Item Name: Crosstube Assembly, Mid Fwd

DART AEROSPACE LTD		Work Order:	98194
Description: Crosstube Assembly, Mid Fwd		Part Number:	D206-667-147TRN
Inspection Dwg: D206-667-147 Rev: A		Page 1 of 2

DART AEROSPACE LTD HAWKESBURY, ONTARIO, CANADA	
DRAWING NO. D206-667-147	REV. A SHEET 1 OF 4
TITLE CROSSTUBE ASS'Y (206L MID FWD)	SCALE NTS
COPYRIGHT © 2010 BY DART AEROSPACE LTD THIS DOCUMENT IS PRIVATE AND CONFIDENTIAL AND IS SUPPLIED ON THE EXPRESS CONDITION THAT IT IS NOT TO BE USED FOR ANY PURPOSES OR COPIED OR COMMUNICATED TO ANY OTHER PERSON WITHOUT WRITTEN PERMISSION FROM DART AEROSPACE LTD.

DRAWING NO. D206-667-147	TITLE CROSSTUBE ASS'Y (206L MID FWD)	REV. A	DART AEROSPACE LTD ENGINEERING ORDER		D.E.O. NO. D206-667-147-A-1	SHEET NO. SHEET 1 OF 1	SCALE NTS
DRAWN P	CHECKED ASS	MFG. APPR. BS	APPROVED MD		DE APPR. H		
DATE 11.07.15	DATE 11.07.20	DATE 11.07.21	DATE 11/07/21		DATE 11.07.21

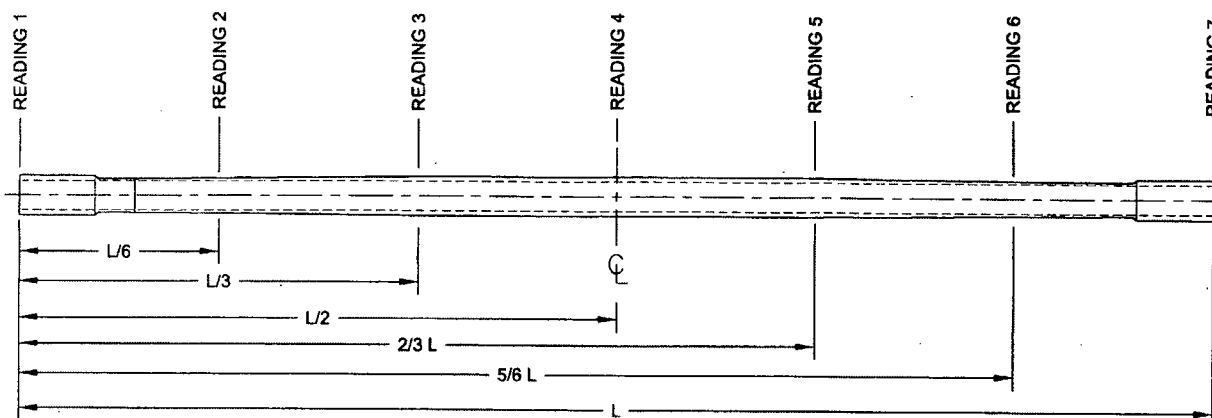
REPLACE MAGNOBOND WITH PROSEAL.

NOTE 12 & 15, SHEET 1 IS AMENDED AS FOLLOWS:

Item	Qty -147	Part Number	Description
9	A/R	PROSEAL 890 B-2	SEALANT, AMS-S-8802 CLASS B-2

- 12) TO INSTALL D2891-1 SUPPORT: ABRABE MATING SURFACE OF SUPPORT AND CROSSTUBE WITH 180-GRIT SANDPAPER AND REMOVE RESIDUE WITH MEK (OR EQUIVALENT). APPLY A 0.04" TO 0.07" THICK LAYER OF PROSEAL 890 CLASS B-2 (OR AMS-S-8802 CLASS B-2) SEALANT TO MATING SURFACE OF SUPPORT.
- 15) TORQUE CLAMPS 80 TO 100 IN.-LB. ENSURE AT LEAST 1.5 THREADS SHOWING IN SAFETY AND THAT NUT HAS NOT BOTTOMED-OUT AFTER TORQUING. **PRIOR TO PACKAGING, RE-CHECK TORQUE ON CLAMPS AFTER PROSEAL 890 SEALANT HAS CURED FOR 72 HOURS.**

SECTION R-R

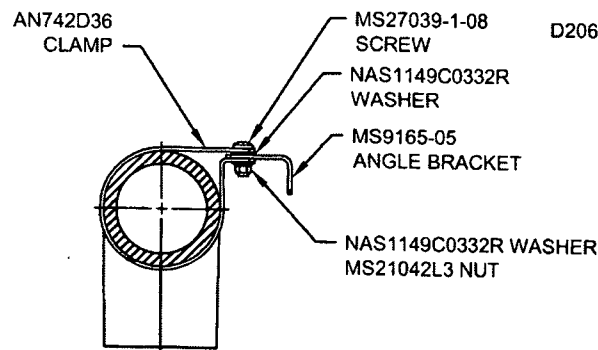
DRAWING NO. D206-667-147		TITLE CROSSTUBE ASS'Y (206L MID FWD)		REV. A		DART AEROSPACE LTD ENGINEERING ORDER		D.E.O. NO. D206-667-147-A-2		SHEET NO. SHEET 1 OF 1		SCALE NTS	
DRAWN AJS		CHECKED		MFG. APPR.		APPROVED		DE APPR.		DATE		DATE	
DATE 12.08.02		DATE 12.08.02		DATE 12.08.02		DATE 12.08.02		DATE 12.08.02		DATE 12.08.02		DATE 12.08.02

ADD ELECTRICAL GROUNDING STRAP

ITEM	QTY	PART NUMBER	DESCRIPTION
1	X	D206-667-147	CROSSTUBE ASSEMBLY (206L MID FWD)
10	2	AN742D36	CLAMP
11	2	MS9165-05	ANGLE BRACKET
12	2	MS21042L3	NUT (OR MS21042-3)
13	2	MS27039-1-08	SCREW
14	4	NAS1149C0332R	WASHER (OR AN960C10L)

- 16) MASK AREA UNDER CLAMP PRIOR TO PAINTING
- 17) SEAL EDGES WHERE AN742D36 CLAMP MEETS WITH THE CROSSTUBE USING SIKAFLEX-241/-291 OR MIL-S-8802 CLASS B2 OR PROSEAL 890 SEALANT
- 18) PERFORM RESISTANCE CHECK TO ENSURE MAX RESISTANCE IS 10 MILLIOHMS
